Access Compliance Report Public Rights-of-Way (Curb Ramps)

Main Street: MARSTON_LN Cross Street: SYLVANOAK_WAY Location: E

ADA ID: RPRK211115121759 Ramp Type: Type 4 - Parallel Initial Pass/Fail: Pass Overall Compliance: No Severity Score: 25

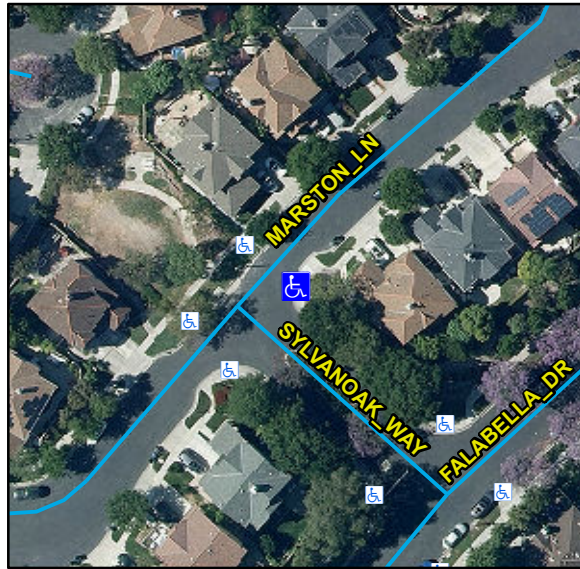
Compliance	Description	Data	Compliance	Description	Data
N/A	Ramp Length LT (in)	145	N/A	Ramp Length RT (in)	137
Yes	Ramp Width LT (in)	51	Yes	Ramp Width RT (in)	51
Yes	Ramp Run Slope LT (%)	5.8	Yes	Ramp Run Slope RT (%)	1
Yes	Ramp Cross Slope LT (%)	0.5	Yes	Ramp Cross Slope RT (%)	0.1
N/A	Landing Present	No	No	DWS Provided	No
N/A	Landing Length (in)	N/A	N/A	DWS Contrast	N/A
No	Landing Width (in)	N/A	N/A	DWS Length (in)	N/A
No	Landing Run Slope (%)	N/A	N/A	DWS Full Width	N/A
No	Landing Cross Slope (%)	N/A		DWS Offset Type	N/A
N/A	Landing Movement Obstructed?	No	N/A	DWS Offset Left (in)	N/A
	Landing Movement Type	Curb	N/A	DWS Offset Right (in)	N/A
N/A	Landing Shared	N/A			
N/A	Clear Space	Yes			
N/A	Clear Space To Crosswalk (in)	48			
N/A	Marked Crosswalk 1	No	N/A	Marked Crosswalk 2	No
	Crossing 1 Direction	NW		Crossing 2 Direction	SW
	Marked Crosswalk 1 Width (in)	N/A		Marked Crosswalk 2 Width (in)	N/A
N/A	Ramp Inside Crosswalk 1	N/A	N/A	Ramp Inside Crosswalk 2	N/A

Crossing 1 Slope (%)	0.8		Crossing 2 Slope (%)	1.4
	Crossing 1 Cross Slope (%)	3.3		Crossing 2 Cross Slope (%)	3.5
Yes	Gutter Ponding	No	Yes	Curb Slope	8.1
Yes	Gutter Lip Height (in)	0		Road Run Slope (%)	6.2
No	Gutter Run Slope (%)	12.7		Road Cross Slope (%)	1.7
No	Gutter Cross Slope (%)	6.9	No	Perpendicular Joint Present	No
Yes	Overall Surface Condition	Acceptable			
	Cross Gutter Present?	No		Spandrel Present?	No
	Replace Cross Gutter?	N/A		Replace Spandrel?	N/A

Remove & Replace Curb Ramp With Two New Directional Ramps or Equivalent. Remove & Replace Gutter.
